RE: Approval Order for Industrial
Wastewater Treatment Facility
Davis County CDS A-1

UTAH BUREAU OF AIR QUALITY
NEW/MODIFIED SOURCE PLAN REVIEW FOR:

RE: Industrial Wastewater Treatment
Facility
Davis County CDS A-1

Figure 1. End of Pipe Air Stripping/Carbon Adsorption Treatment Process.

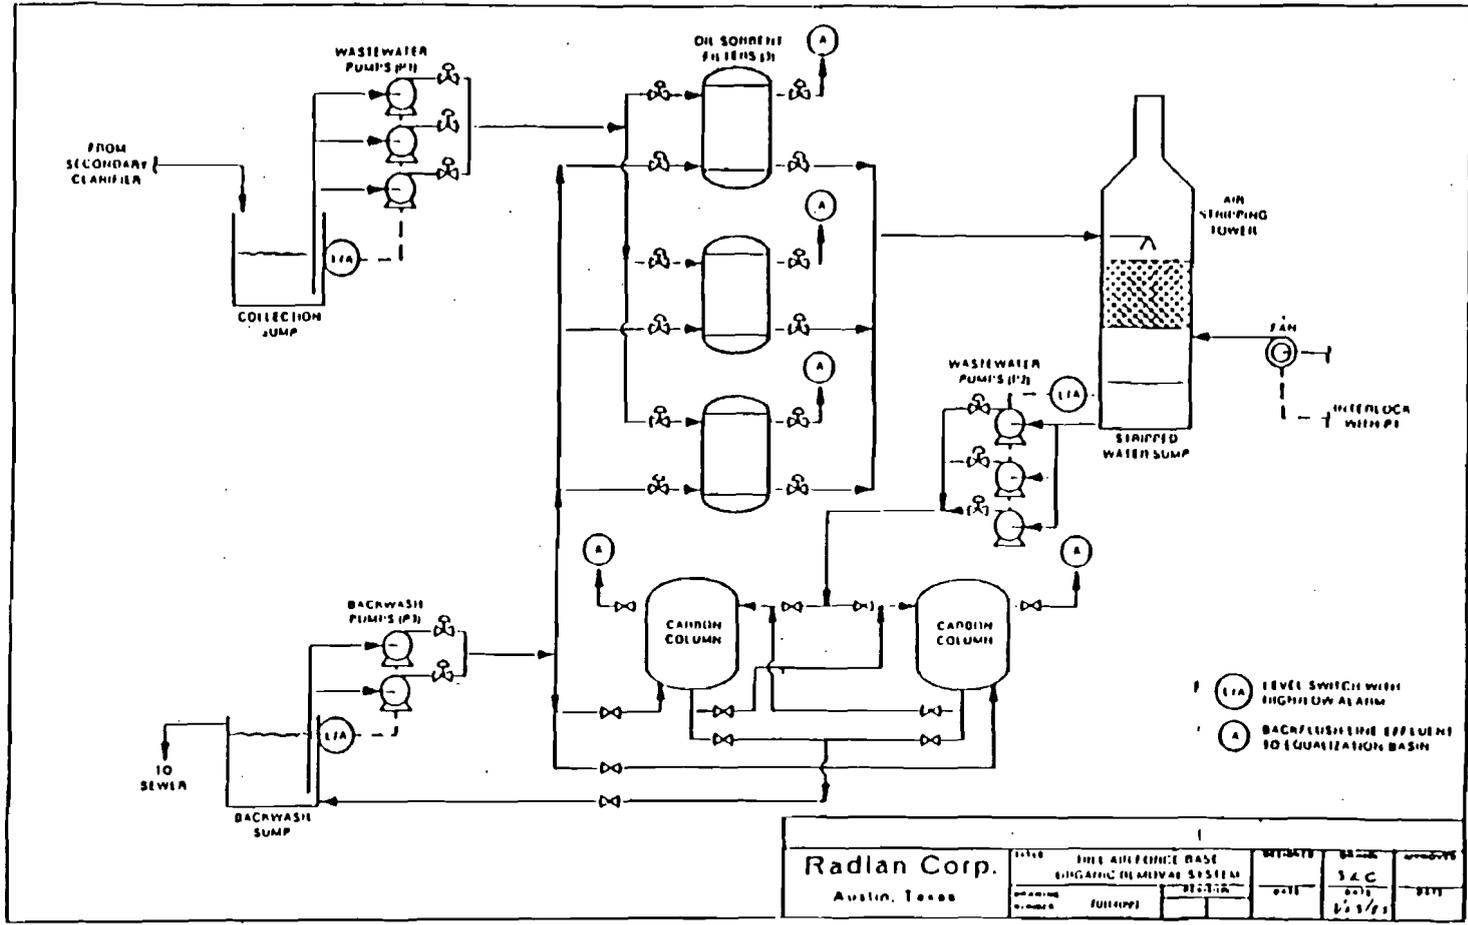
The facility will be stripping the reactive and non-reactive hydrocarbons from the wastewater. The waste HC stripped currently enters the atmosphere so this is not a change of HC emissions for existing rates of effluent. The increased effluent for Building 220 expansion will be included in this review.

75% of the HC stripped from the water is non-reactive as defined by UACR Section 3.1.7.f.

The system is closed to the atmosphere except the air stripping tower where the HC is removed by a counter current flow of air contacting water in a packed tower. See Figure 1.

The air stripper is expected to remove 99.9% of the VOC from the water.

I recommend no control equipment with the following limitations:

1. Annual reporting of reactive and non-reactive VOC emissions.
2. Reactive VOC shall not exceed 12 ton/yr.
